BNL CCWF II
Addendum 2
Revised Drawings

JOB NO.	SHEET NO.	REVISION	DATE	DWN.	APP'D.	CK
		A Addendum #2	4/14/09

JOB TITLE: CENTRAL CHILLED WATER FACILITY PHASE II		DWG. TITLE: SITE PLAN	
R.R.GPP,J.M., HEM	DATE	ACCT. NO.	SHEET OF
SCALE 1"=20'-0"	DWN. BY SSK / REV'D BY XX	JOB NO. 11705	DWG. NO. CE-03
ESHQ RISK LEVEL	APP'D. BY	BLDG. NO. 600	
PATH:

ONE LINE DIAGRAM

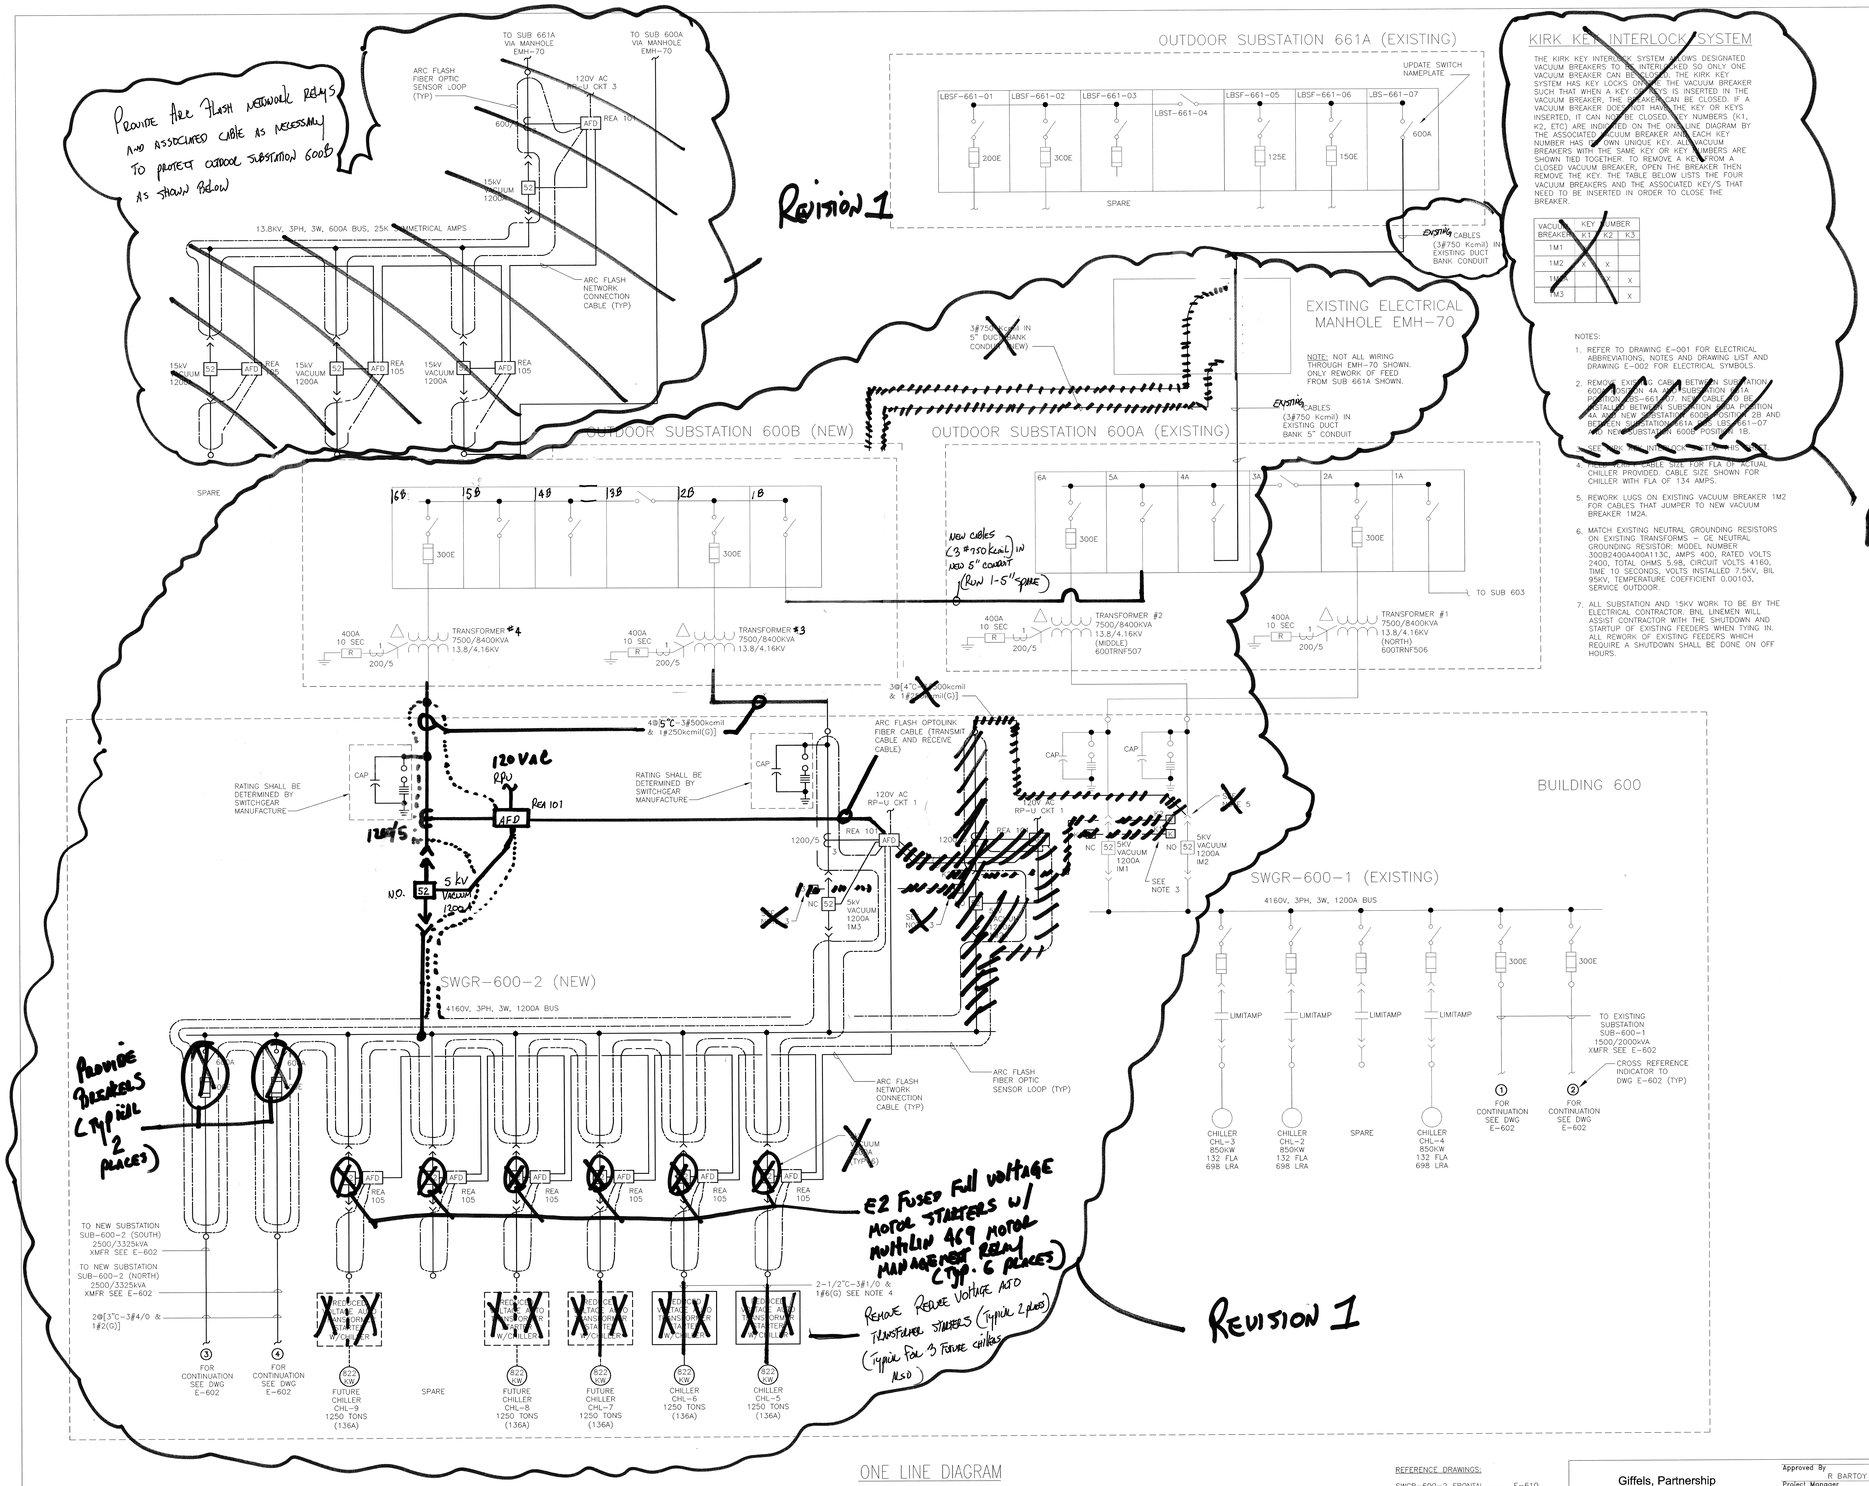
5. REWORK LUGS ON EXISTING VACUUM BREAKER 1M2 FOR CABLES THAT JUMPER TO NEW VACUUM BREAKER 1M2A.
6. MATCH EXISTING NEUTRAL GROUNDING RESISTORS ON EXISTING TRANSFORMS – GE NEUTRAL GROUNDING RESISTOR: MODEL NUMBER 30GB400A400A113C, AMPS 400, RATED VOLTS 2400, TOTAL OHMS 5.98, CIRCUIT VOLTS 4160, TIME 10 SECONDS, VOLTS INSTALLED 7.5kV, BIL 95kV, TEMPERATURE COEFFICENT 0.00103, SERVICE OUTDOOR.

Revision 1

201A SWITCHGEAR SWGR-600-2 FRONTAL
1/2" = 1'-0"

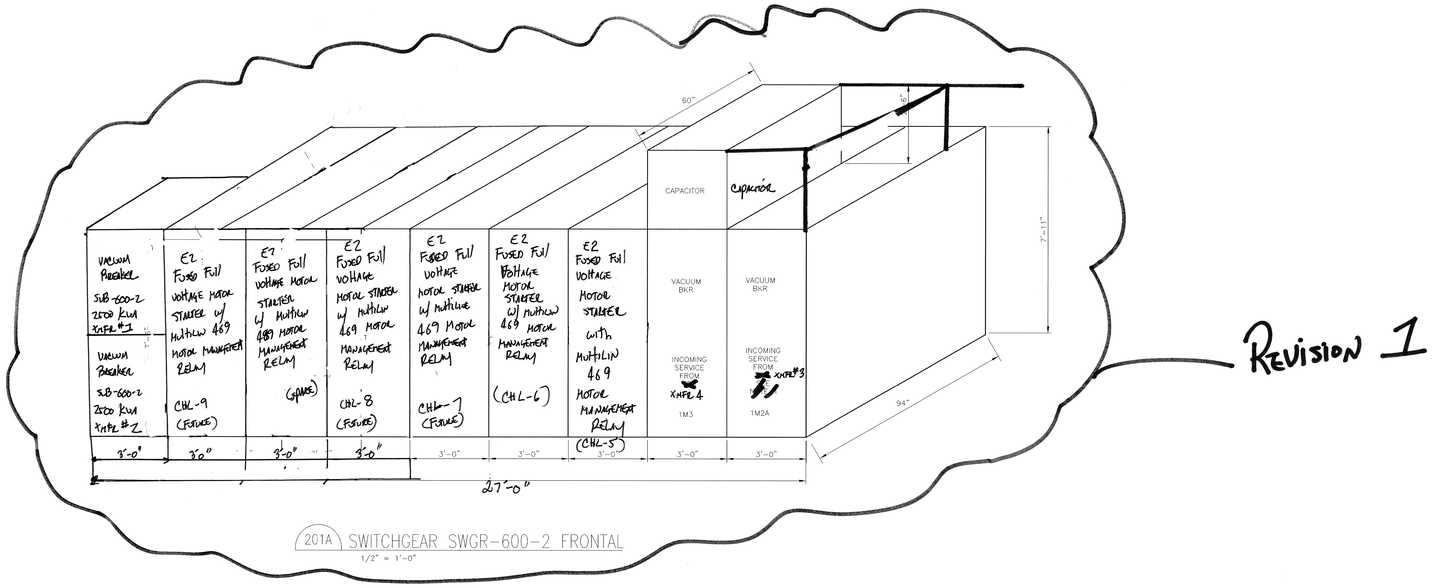
Revision 1

1. [illegible]
2. USE ONE SHOT OR FULL SHOE BENDERS TO MAKE 13" BEND RADIUS – REFER TO NEC CHAPTER 9 TABLE 2.
3. USE ONE SHOT OR FULL SHOE BENDERS TO MAKE 15" BEND RADIUS – REFER TO NEC CHAPTER 9 TABLE 2. ROUTE TWO 3-1/2"C FOR FEED TO MCC-600A-2 BELOW TWO 3"C.

201B SUBSTATION SUB-600-2 FRONTAL
1/2" = 1'-0"

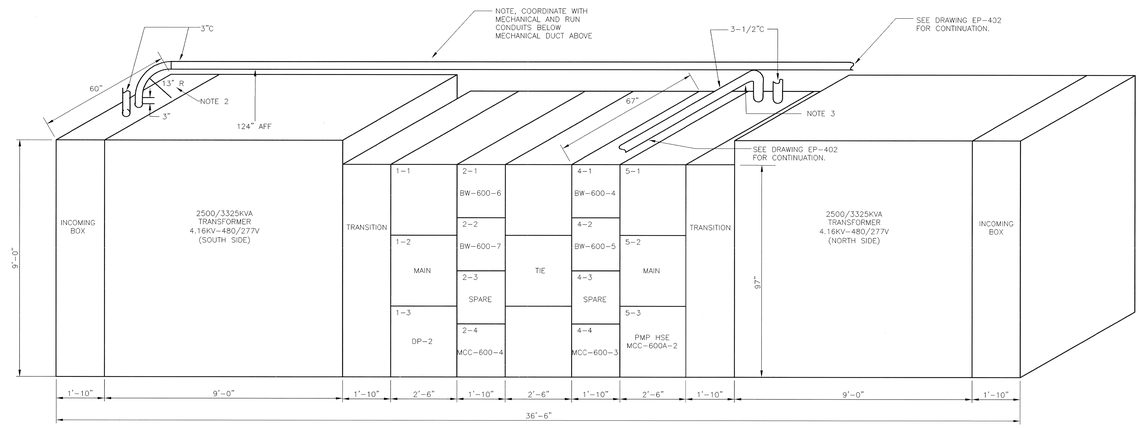
Revision 1

BUILDING 600 POWER PLAN ELECTRICAL MEZZ

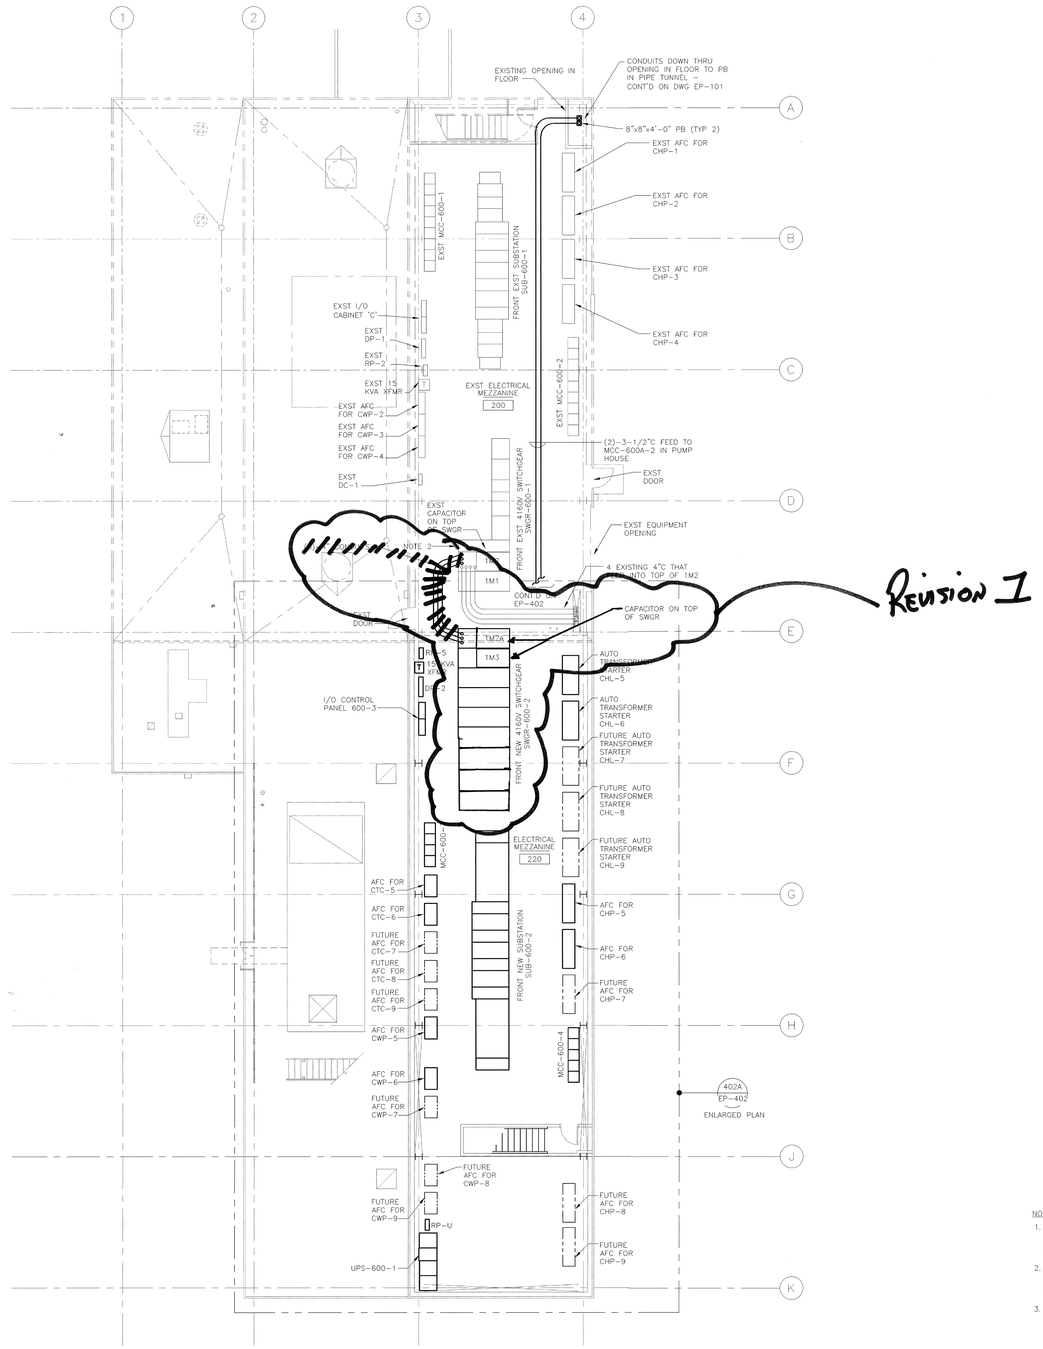
1. REFER TO DRAWING E-001 FOR ELECTRICAL ABBREVIATIONS, GENERAL NOTES AND DRAWING LIST AND DRAWING E-002 FOR ELECTRICAL SYMBOLS.
2. REWORK LUGS ON VACUUM BREAKER 1M2 FOR CABLES THAT JUMPER TO NEW VACUUM BREAKER 1M2A – SEE ONE LINE DIAGRAM DRAWING E-601.
3. ALL EQUIPMENT DESIGNATED FUTURE ARE NOT PART OF THIS CONTRACTOR.

302A BUILDING ELECTRICAL DUCT BANK SECTION
EP-400 EP-401 1/8" = 1'=0"

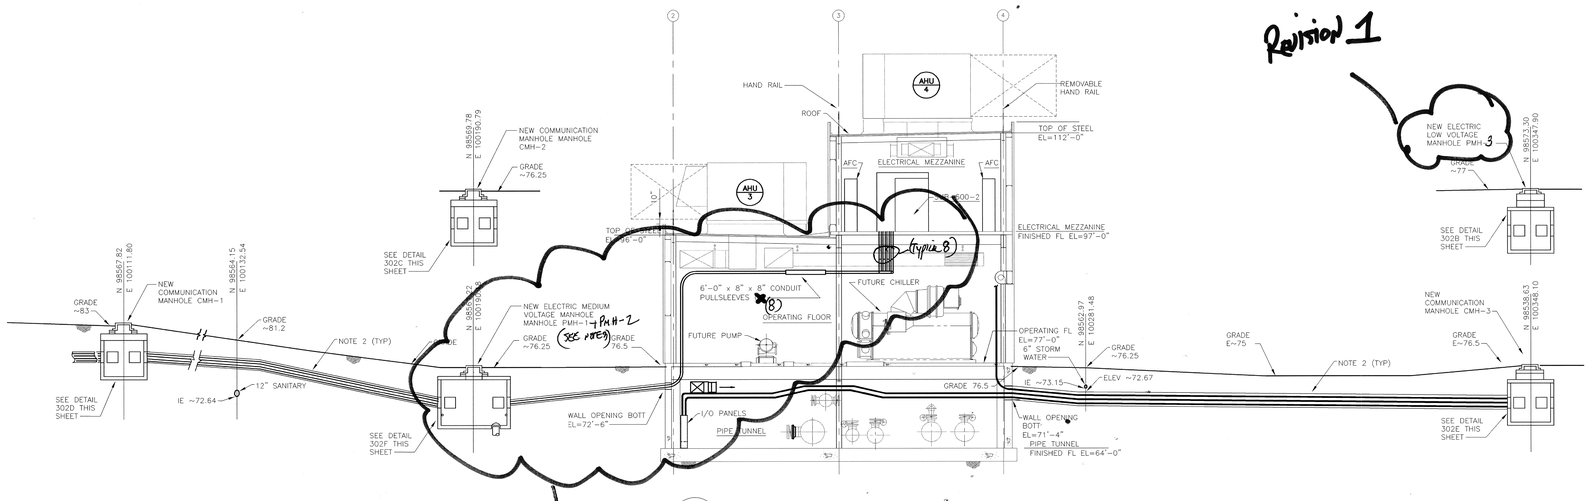
Revision 1

1. REFER TO DRAWING E-001 FOR ELECTRICAL ABBREVIATIONS, GENERAL NOTES AND DRAWING LIST AND DRAWING E-002 FOR ELECTRICAL SYMBOLS.
2. TOP OF DUCT BANK TO BE MINIMUM OF 30 INCHES BELOW GRADE WITH MINIMUM SLOPE OF 12 INCHES PER 100 FEET.
3. DUCTBANK ASSOCIATED WITH PMH-2 INSTALLED AT XMPR #4 AND ENDS AT SUB-600-2 ON ELECTRICAL MEZZANINE, SEE DWG. ES-101 FOR FURTHER DETAILS

402A ENLARGED POWER PLAN ELEC MEZZANINE
EP-102 1/4" = 1'-0"

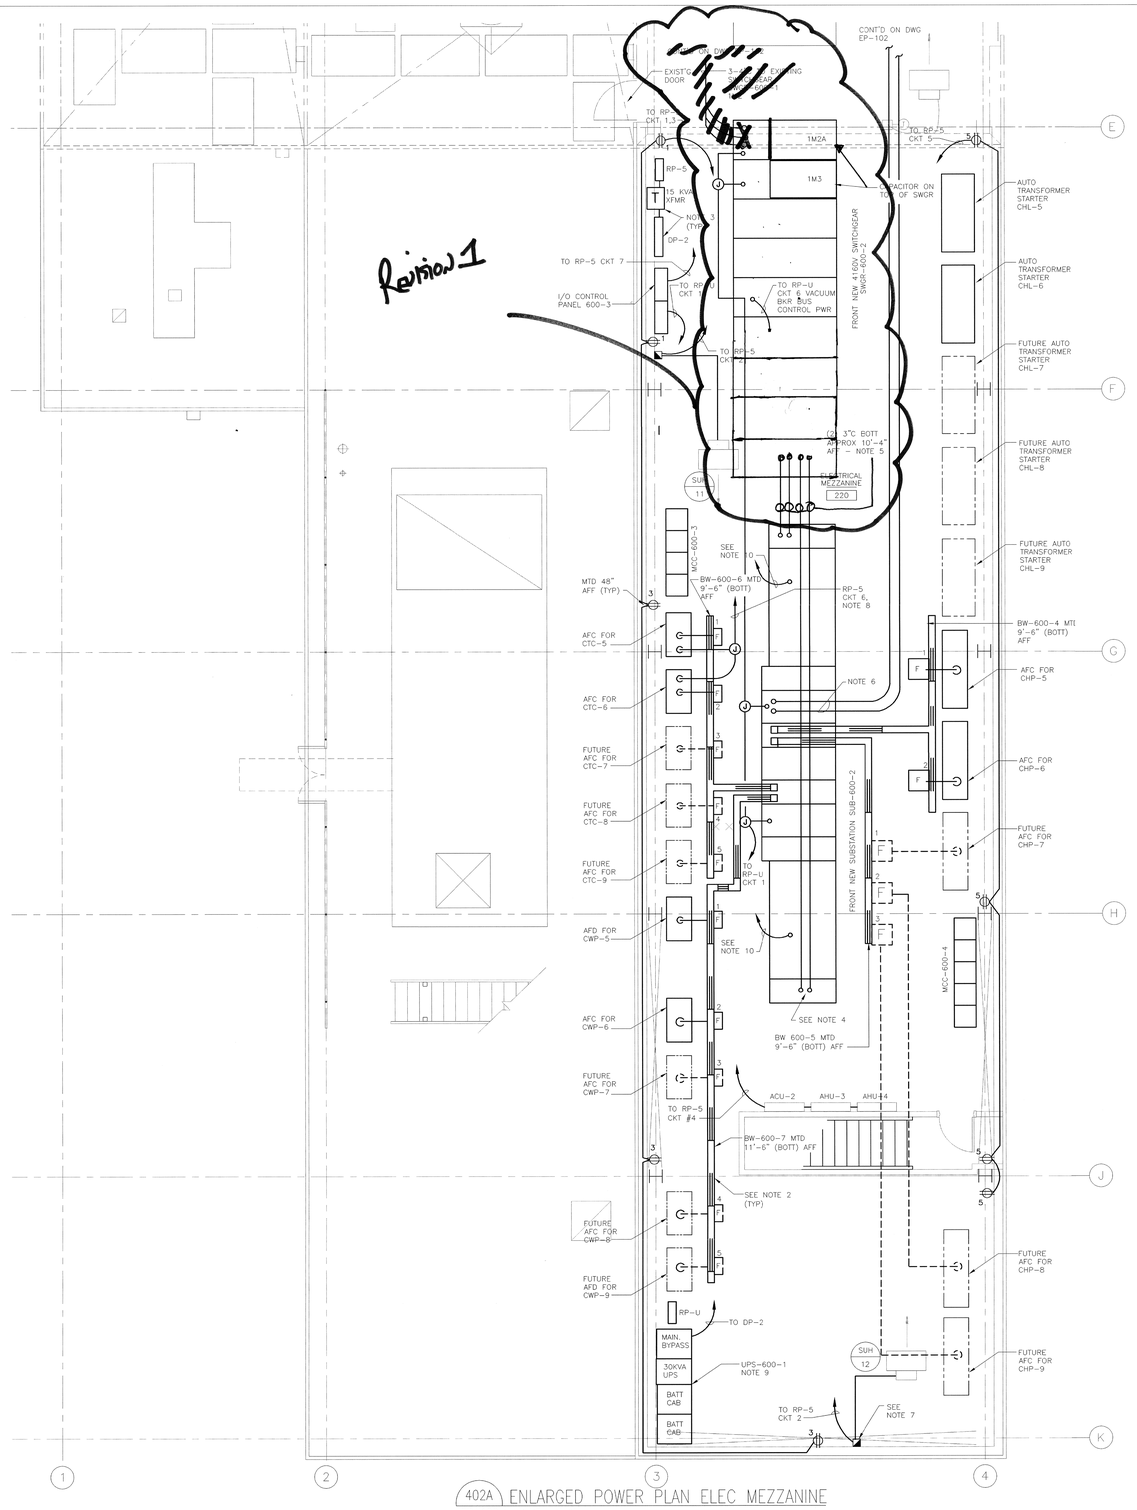
Revision 1

6. SEE [illegible] SUB-600-2 FRONTAL ON DRAWING E-610 WHICH SHOWS THE (2) 3-1/2"C ENTRY INTO THE TOP OF THE SUBSTATION - FOR FEED TO MCC-600A-2 IN THE PUMP HOUSE.

8. 120V THRU DRIVE AUXILIARY CONTACT FOR COOLING TOWER FAN MOTOR HEATER POWER.
9. PROVIDE ONE 30KVA/24KW THREE PHASE UNINTERRUPTIBLE POWER SUPPLY, BATTERY POWER PACKS AND MAINTENANCE BYPASS CABINET AS FOLLOWS:

ELECTRICAL SITE PLAN

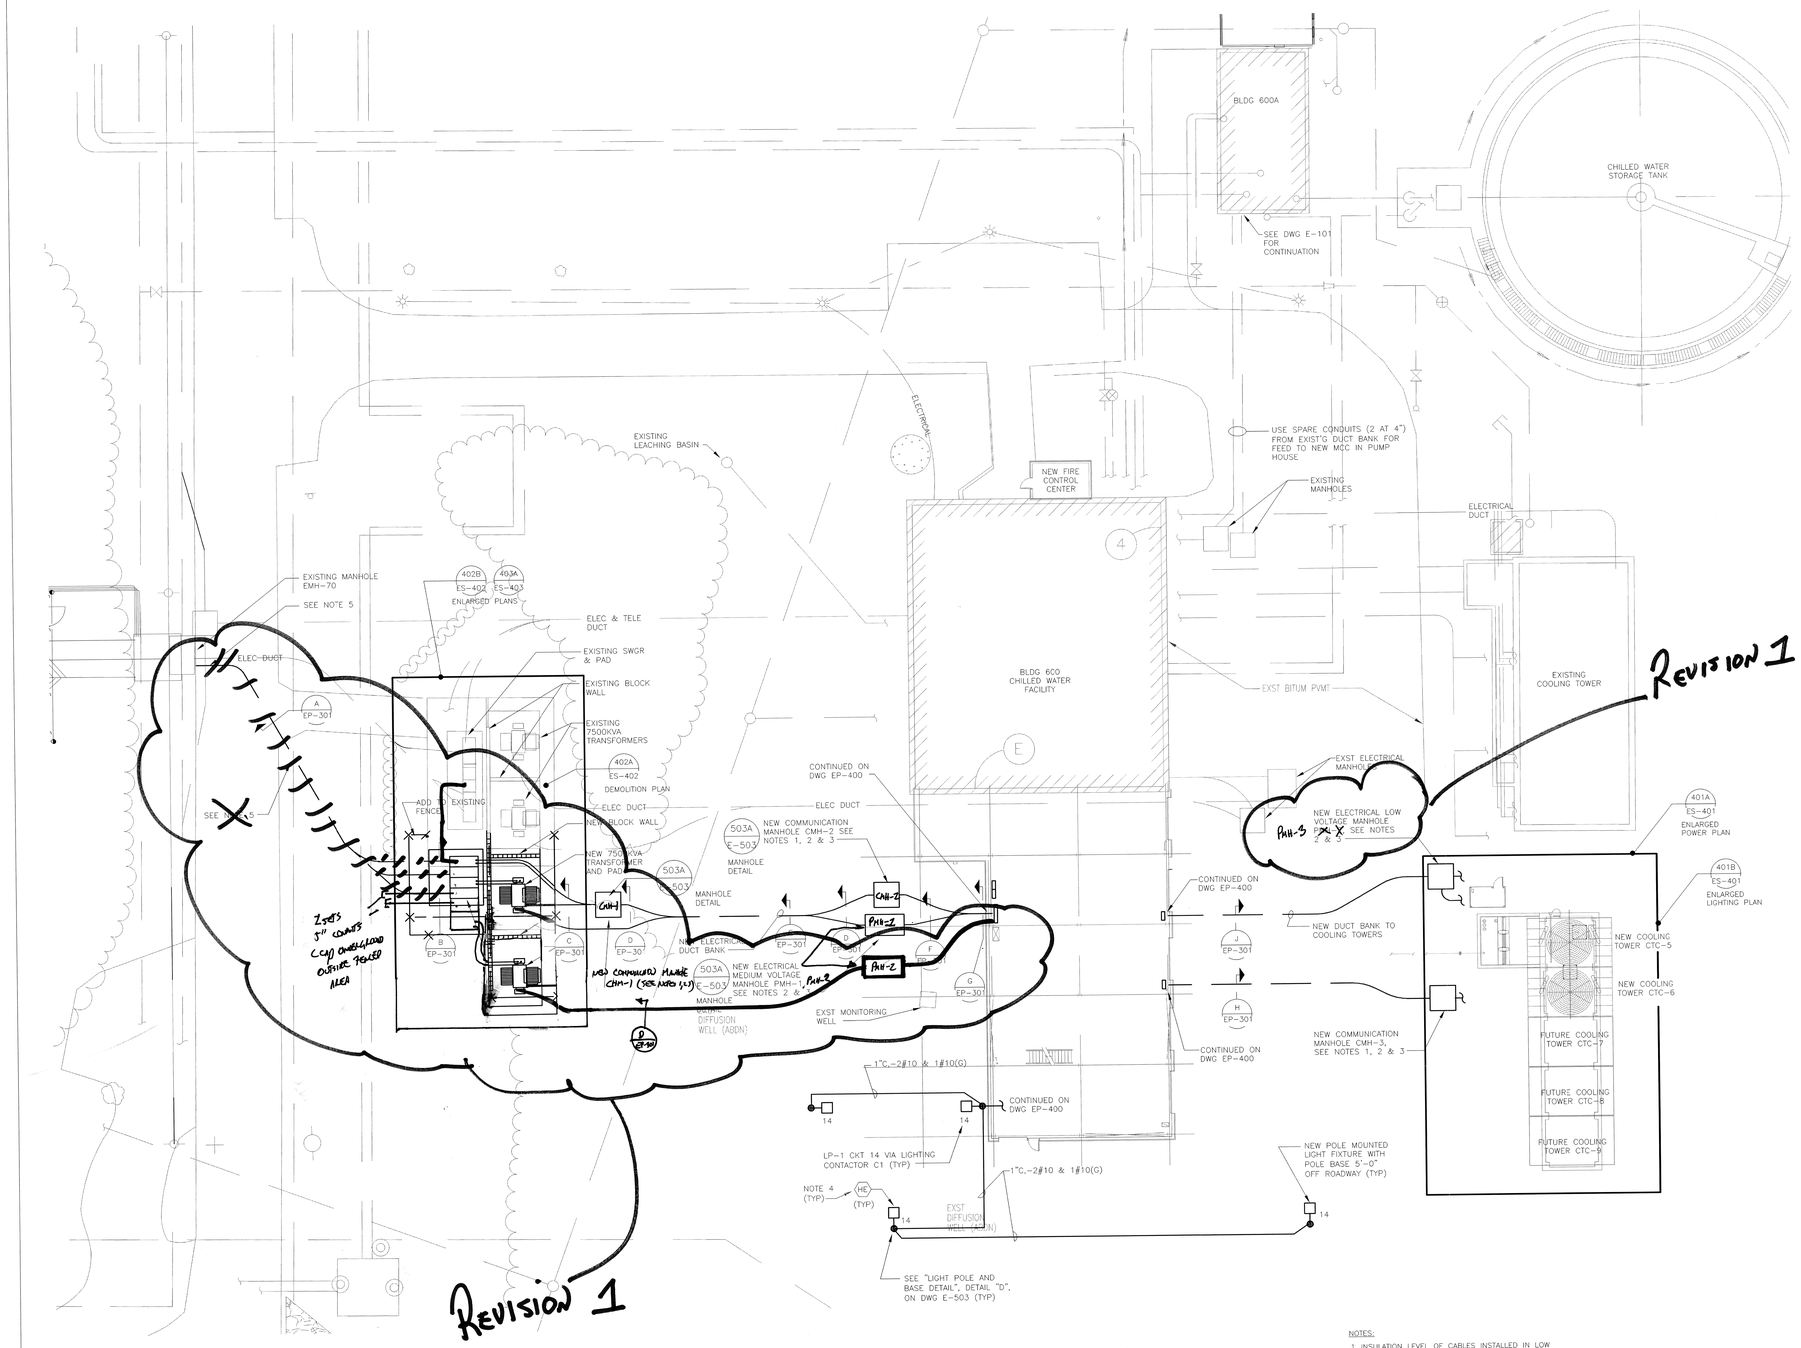
REVISION 1
